TECHNICAL BULLETIN — October 2015

394. Wisdom Rides Gravitron/Centrifuge service bulletins

**RIDE: GRAVITRON, STARSHIP ALIEN ABDUCTION
AND CENTRIFUGE**

**SUBJECT: TRAP DOOR MICROSWITCH
INSTALLATION**

TRAP DOOR MICROSWITCH INSTALLATION

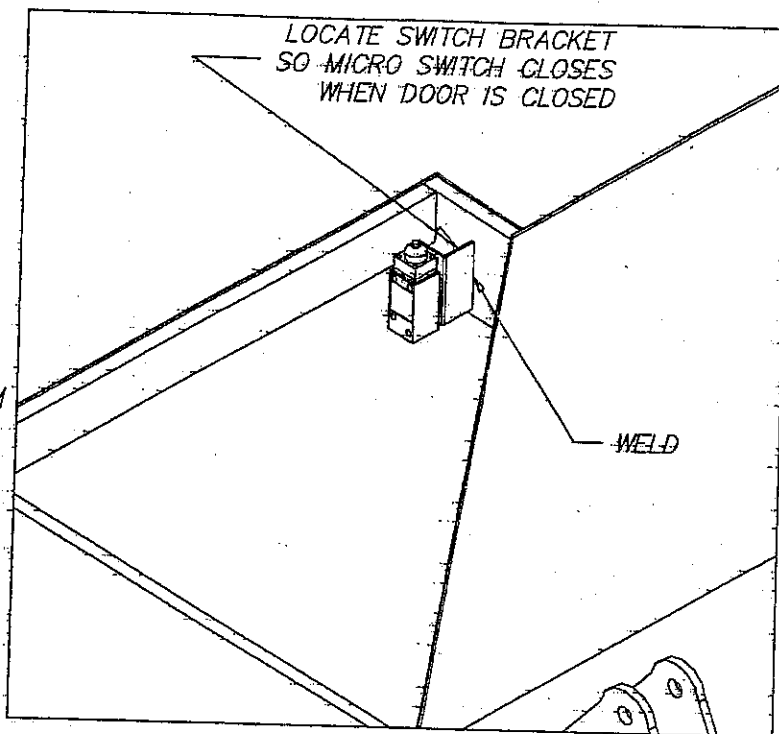
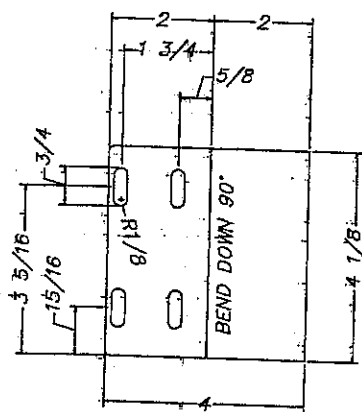
Due to the risk of employees being injured by standing in the trapdoor of the Gravitron/Starship/Alien/Centrifuge rides, it is required that the trapdoor be closed at all times. Some agencies require that the trapdoor be permanently closed by welding.

Some agencies require that the trapdoor be accessible as a second means of egress. If this is the case, attached is a system to interlock the trapdoor with the drive system so that when the door is open the drive system is disabled and the operator cannot energize the main motor with the trapdoor open.

1. REMOVE WHITE WITH RED STRIPE FROM COMMUTATOR.
2. ATTACH TO ONE WIRE FROM MICROSWITCH.

3. ATTACH OTHER WIRE FROM MICROSWITCH TO THE RING THAT THE WHITE WITH RED STRIPE WAS CONNECTED TO.

4. WIRES ATTACH TO THE NORMALLY OPEN CONTACTS IN MICROSWITCH.
